CERTIFICATE OF APPROPRIATENESS

Applicant: Sam Gianukos, Creole Design, LLC for Adrian Guerra-Paz, owner

Property: 620 Columbia Street, Lot 17, Block 281, Houston Heights Subdivision. The property includes a historic 1,279 square foot one-story wood frame single-family residence and rear detached garage situated on a 6,600 square foot (50' x 132') interior lot.

Proposal: Alteration – Addition

NORTH SIDE ELEVATION

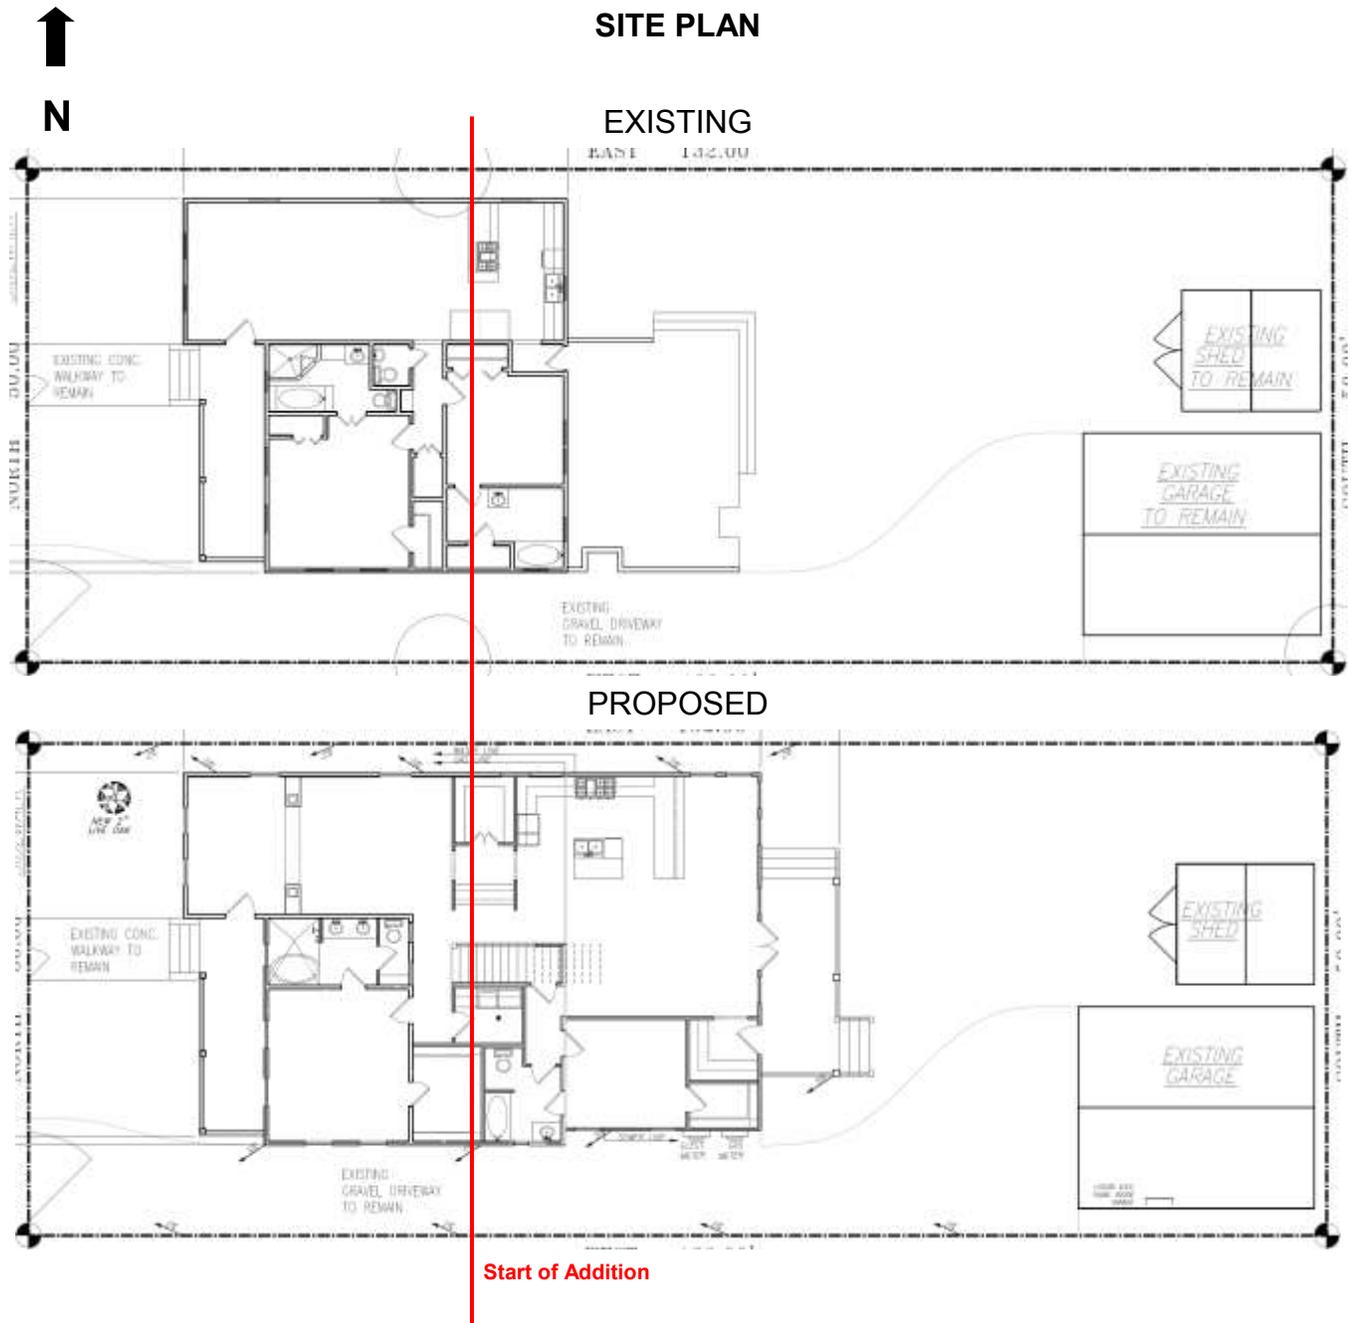
<i>The removal of original sash windows on the north and south elevations results in the removal of historic material and changes the original fenestration pattern, both of which are part of the historic character of the residence and distinguishing qualities of the residence, The second story of the addition encroached 9' on to the historic one-story residence, the second floor of the addition will require that the north and south historic walls be reframed in order to carry the load of the addition and will remove part of the original cross gable roof that is a distinguishing quality of the Queen Anne residence. The two-story addition that encroaches on the one-story residence result in the loss of distinguishing qualities and alters the historic character of the residence.</i> |

<i>The two-story rear addition encroaches 9'-2" on to the existing one-story residence which results in the removal of a large portion of the existing roof structure, north and south walls, and two original sash windows. Approximately 1/3 of the historic house will be removed for this addition, which destroys the essential form and integrity of the house. The second floor of the addition that encroaches on to the historic one-story Queen Anne residence will require that the north and south walls of the historic structure be structurally reinforced to carry the load of the second floor. This may require that the walls be completely reframed and rebuilt. The two-story addition alters the original form of the residence by introducing a second floor onto the one-story Queen Anne residence. If the addition were moved off the existing structure, the one-story form of the Queen Anne residence would be left intact,</i> |

Side Elevation: The residence features three 4-over-4 sashes; the rear window will be removed. The addition will (North) feature two 1-over-1 sashes on the first floor and four 1-over-1 sashes on the second floor.

Side Elevation: The residence features a 2-lite wood paneled entry door with a transom, two 4-over-4 sashes, and (South) a 1-over-1 sash; the 1-over-1 sash will be removed. The addition will feature a single lite fixed window and two 1-over-1 sashes on the first floor and two 1-over-1 sashes and a single lite fixed window on the second floor.

- The original rear 4-over-4 sash window on the north elevation to be retained and walled over on the interior.
- Any original siding that is intact under the existing asbestos shingles it is to be retained and repaired.
